<b>EASA</b>	<b>AIRWORTHINESS DIRECTIVE</b>	
	<p><b>AD No.: 2014-0018R1</b>  <b>[Correction: 23 January 2014]</b></p> <p><b>Date: 20 January 2014</b></p> <p>Note: This Airworthiness Directive (AD) is issued by EASA, acting in accordance with Regulation (EC) No 216/2008 on behalf of the European Community, its Member States and of the European third countries that participate in the activities of EASA under Article 66 of that Regulation.</p>	
<p>This AD is issued in accordance with EU 748/2012, Part 21.A.3B. In accordance with EC 2042/2003 Annex I, Part M.A.301, the continuing airworthiness of an aircraft shall be ensured by accomplishing any applicable ADs. Consequently, no person may operate an aircraft to which an AD applies, except in accordance with the requirements of that AD, unless otherwise specified by the Agency [EC 2042/2003 Annex I, Part M.A.303] or agreed with the Authority of the State of Registry [EC 216/2008, Article 14(4) exemption].</p>

<p><b>Design Approval Holder's Name :</b> AIRBUS</p>		<p><b>Type/Model designation(s) :</b> A300, A300-600, A300-600ST and A310 aeroplanes</p>
<p>TCDS Numbers : France No. 145 and EASA.A.014</p>		
<p>Foreign AD : None</p>		
<p>Revi

Appendix 1

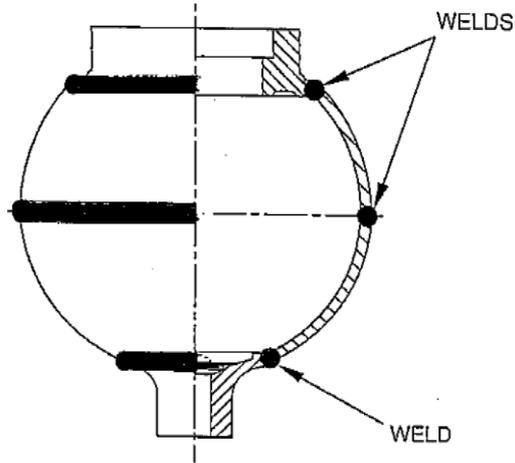
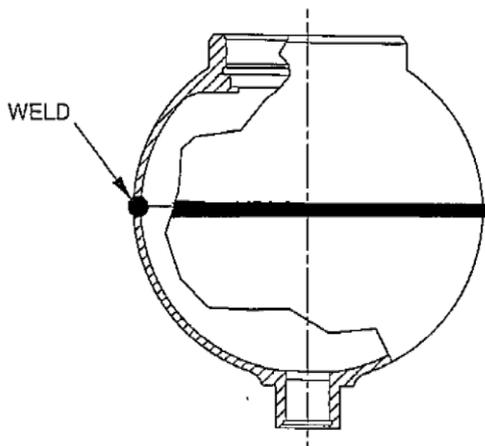
**HYDRAULIC ACCUMULATOR** : designed with 4 parts and 3 welds

**OLD DESIGN**

**HYDRAULIC ACCUMULATOR** : designed with 2 parts and 1 weld

**NEW DESIGN**

<p>(1.2) If, during the visual inspection as required by paragraph (1.1) of this AD, an old design hydraulic accumulator is found installed on any of the affected hydraulic circuits as indicated in Table 1 of this AD, as applicable to aeroplane model, replace each affected old design accumulator with a new design accumulator in accordance with the instructions of Airbus SB A300-29-0126 Revision 01, SB A310-29-2099, SB A300-29-6063, or SB A300-29-9012, as applicable to aeroplane model.</p> <p>(1.3) Irrespective of findings during the visual inspection as required by paragraph (1.1) of this AD, install placards at the designated locations of the affected hydraulic circuits indicated in Table 1 of this AD, as applicable to aeroplane model, in accordance with the instructions of Airbus SB A300-29-0127, SB A310-29-2100, SB A300-29-6064, or SB A300-29-9013, as applicable to aeroplane</p>	Affected aeroplanes	Affected hydraulic circuit(s)	A300, without Airbus Modification (Mod) 02447 embodied in production	Blue and Green	A300, with Airbus Mod 02447 embodied in production	Blue	A300-600 and A300F4-608ST	A310	Green
Affected aeroplanes	Affected hydraulic circuit(s)									
A300, without Airbus Modification (Mod) 02447 embodied in production	Blue and Green									
A300, with Airbus Mod 02447 embodied in production	Blue									
A300-600 and A300F4-608ST										
A310	Green
